6.5L Engine Replaces 6.2L

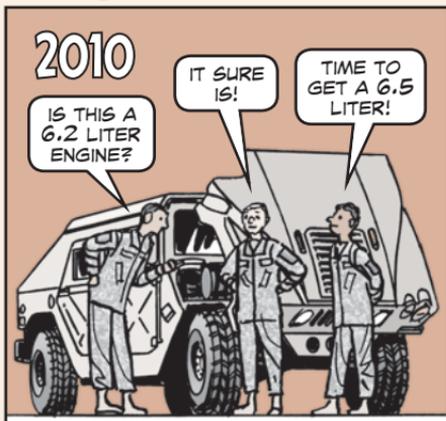
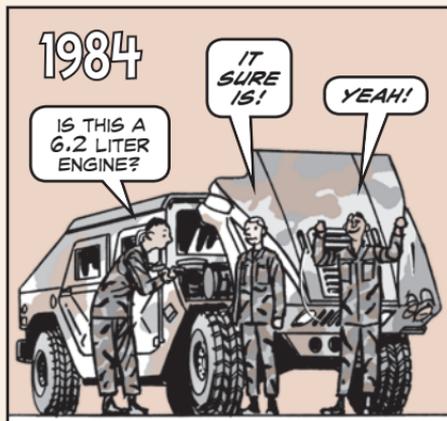
Note that some repair sites are receiving 6.2L engines turned in to the 6.5L engine repair programs, but they shouldn't. Avoid extra transportation costs and wasted time by making sure you send the right engine to the right place. The 6.5L engine block has a turbo mounting bracket, but the 6.2L engine block does not.
